Local Planning Panel

503-505 Elizabeth Street, Surry Hills

D/2020/20

demolition of existing buildings and construction of a new 7 storey mixed use development

height non compliance

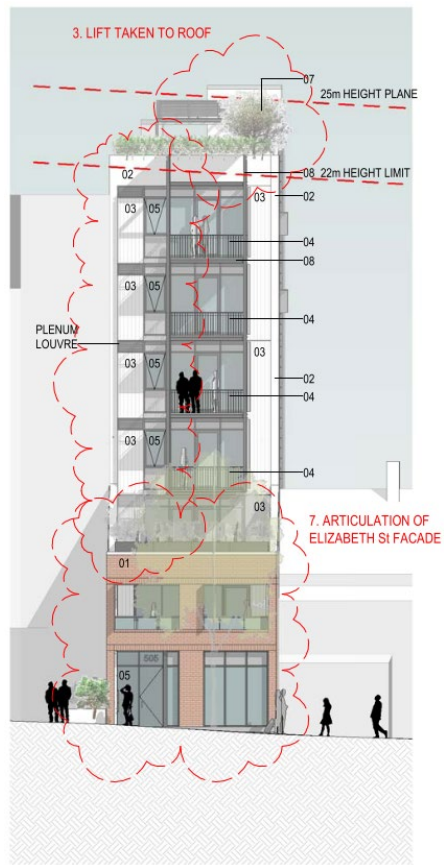
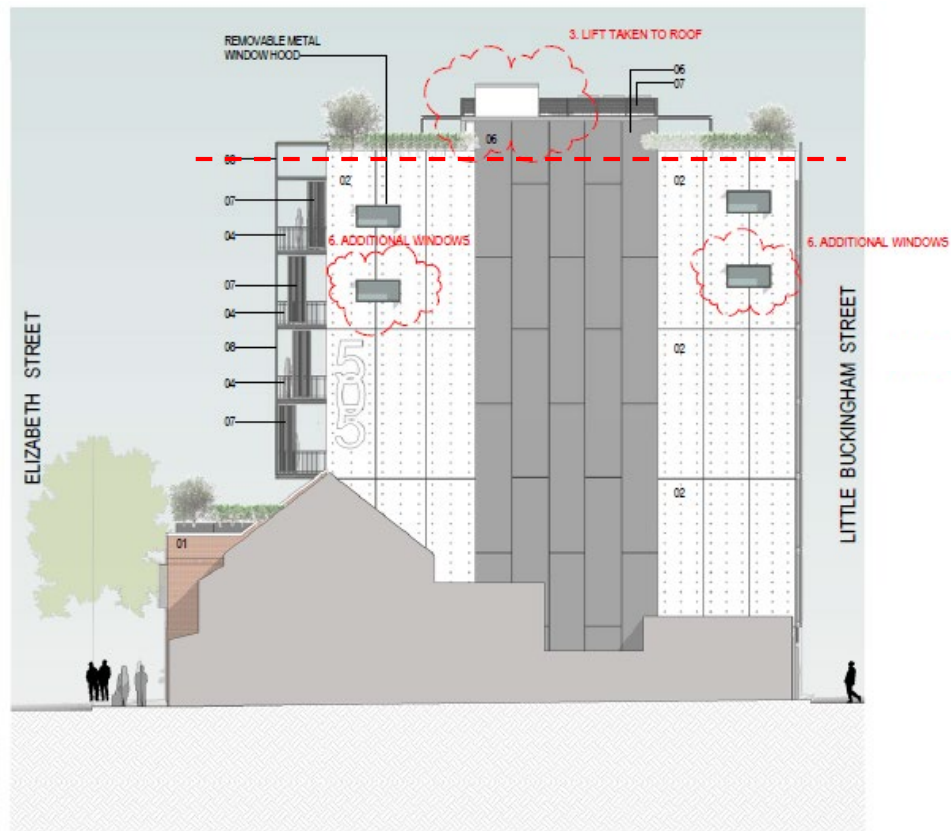
- proposed building exceeds height in metres and height in storeys controls
- exceeds height of building to south and does not provide appropriate height transition to contributing terraces
